Housing Development, Abbeyleix
Road, Portlaoise

Stage 1 Road Safety Audit

Document Ref:	P22-082-RSA-PD-RP-001
----------------------	------------------------------

Location: Drawing 1933-OBFA-DR-A-2003

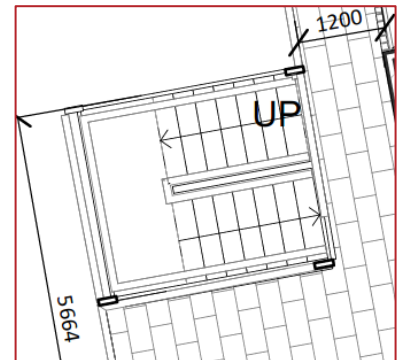
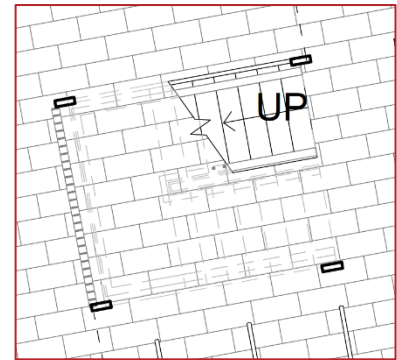
Summary: Tactile paving has not been indicated at the top and bottom of steps within the proposed development.

Tactile paving has not been indicated at the top and bottom of the steps within the proposed development. This may lead to a visually impaired pedestrian being insufficiently aware of the hazard and continuing towards the steps without due care and attention, resulting in trips and falls at the bottom of the steps, and personal injuries, or falls from a height at the top of the steps, and serious injuries.

Corduroy tactile paving should be provided at the top and bottom of the steps within the development.

Location: Drawing 1933-OBFA-DR-A-2003

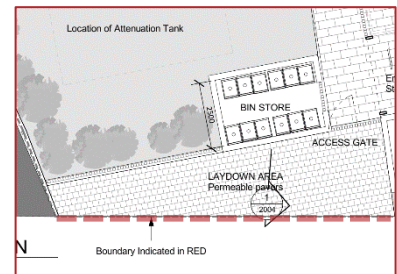
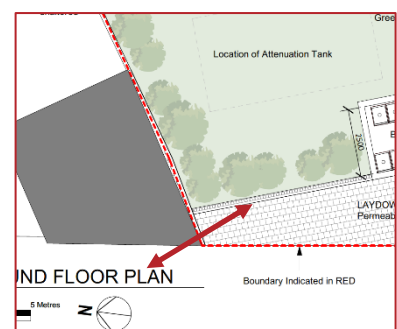
Summary: Visually impaired pedestrians may be unable to differentiate between the laydown area and adjacent Old Abbeyleix Road carriageway.

A laydown area with a surface composed of permeable pavers has been indicated at the western boundary of the proposed development adjacent the Old Abbeyleix Road. Visually impaired pedestrians exiting the development at this location may be unable to differentiate between the laydown area and the adjacent Old Abbeyleix Road carriageway. This could lead to a visually impaired pedestrian inadvertently entering the Old Abbeyleix Road carriageway where there is an increased risk of being struck by a vehicle

Tactile paving, or a similar warning strip, should be provided along the interface between the laydown area and the Old Abbeyleix Road carriageway.

Location: Drawing 1933-OBFA-DR-A-2003

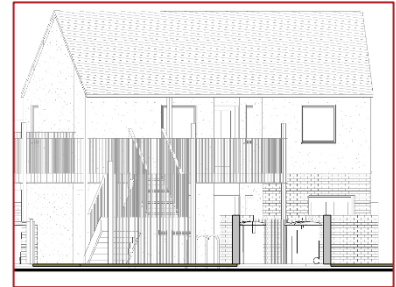
Summary: The adjacent building to the north of the development may restrict inter-visibility between a driver on the Old Abbeyleix Road and a pedestrian exiting the laydown area.

There is an existing building located to the north of the proposed development which borders the northern end of the laydown area at the development's western boundary. The building may block inter-visibility between a southbound driver on the Old Abbeyleix Road and a pedestrian exiting the laydown area resulting in a pedestrian exiting into the path of an oncoming driver who may have insufficient time to react resulting in an increased risk of vehicle-pedestrian collisions.

Provide landscaping within the laydown area adjacent the existing building to create a buffer zone, which will have the effect of maximising inter-visibility between drivers and pedestrians.

Location: Drawing 1933-OBFA-DR-A-2004

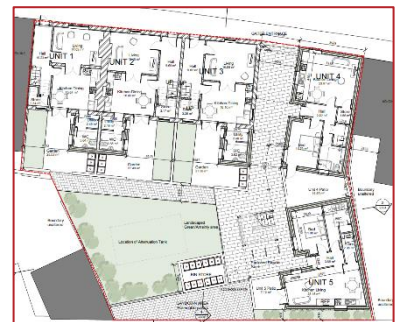
Summary: The vertical clearance beneath the first floor walkway and steps is unclear and, if too low, may present a hazard to pedestrians and cyclists.

A walkway has been indicated at first floor level which is accessed by steps and overhangs the ground floor level within the development. The vertical clearance between the walkway/steps and the surface has not been indicated and there is a risk that, if too low, the overhang of the walkway or corner of the steps may present a hazard to vulnerable road users, particularly cyclists, resulting in them striking the overhang/steps and suffering personal injuries. This would be a particular concern during the hours of darkness.

Ensure the vertical clearance between ground level and the overhang/steps is a minimum of 2.5m to accommodate cyclists.

Where this clearance cannot be achieved (e.g. where the steps rise or at landing areas on the steps) measures should be provided to clearly highlight the hazard to pedestrians and cyclists which should be sufficiently visible during the hours of darkness.

Location: Site visit observation

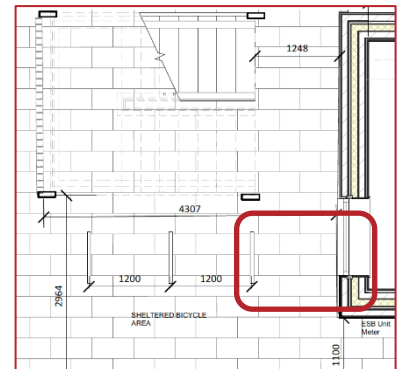
Summary: It is unclear if the existing dropped kerb at the existing vehicular access on the N80 is to be removed and, if retained, it may lead to visually impaired pedestrians being unable to detect the edge of the carriageway.

There is an existing dropped kerb within the footpath on the western side of the N80 at the existing vehicular access to the site of the proposed development. Vehicular access is not proposed to the development from the N80 resulting in the dropped kerb no longer being necessary. It is unclear if it is intended to remove the dropped kerb as part of the proposed development. If retained, it may lead to a visually impaired pedestrian on the footpath, or when exiting the development, being unable to detect the edge of the carriageway resulting in them inadvertently entering the N80 carriageway where there is an increased risk of being struck by a vehicle.

The dropped kerb should be replaced with a full height kerb, and the footway raised to match the full height kerb line.
